From: [Tom, Vivian](#)
To: [Guo, Shelley](#); [Cheong, Winola](#)
Cc: [Downtown West Project](#)
Subject: Downtown West Infrastructure Review
Date: Tuesday, March 16, 2021 11:03:50 AM
Attachments: [Revised Infrastructure Document - Sewer.pdf](#)

9.2. DISTRICT WASTEWATER COLLECTION SYSTEM

Figure 9.3. Proposed Wastewater Collection Network

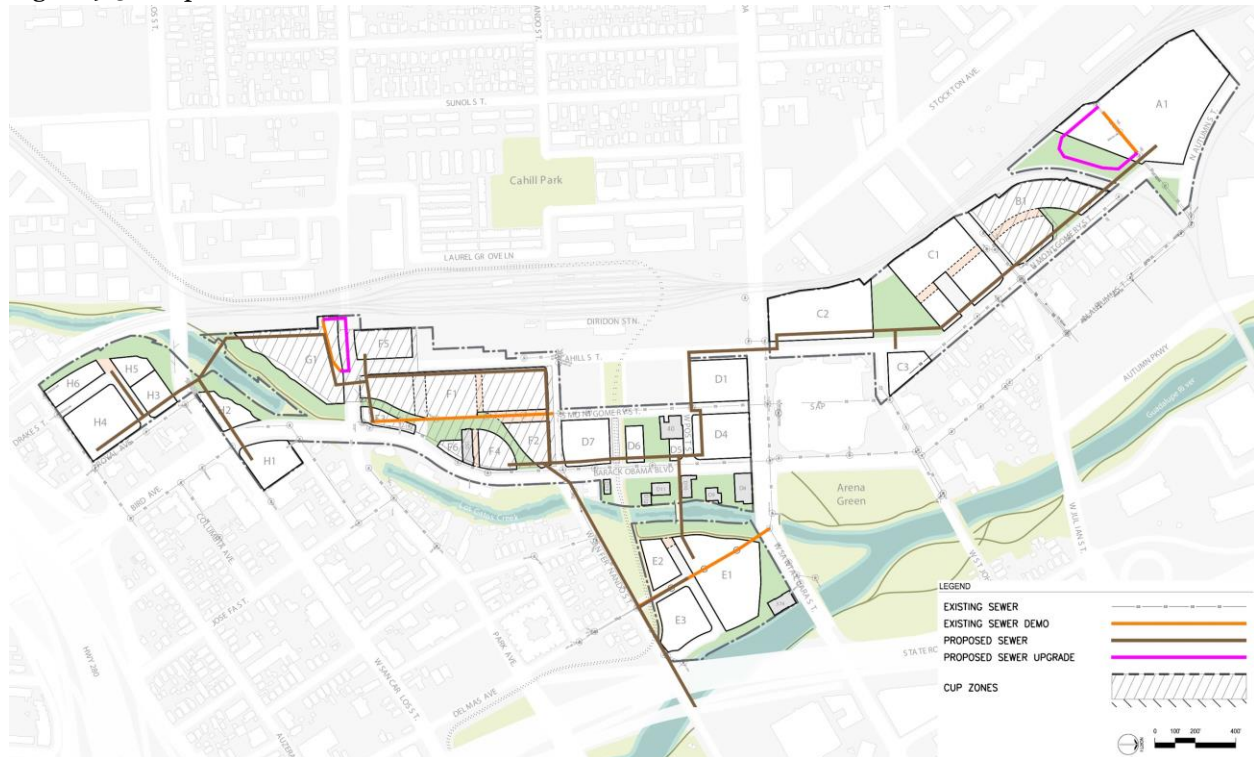
City Comment: Provide details on parcels not served by district system.

Response: Discussion on parcels that will connect to City system (Table 9.1), which according to Google, will be about 600 units (I'm trying to get more info on parcel type and discharge breakdown from them).
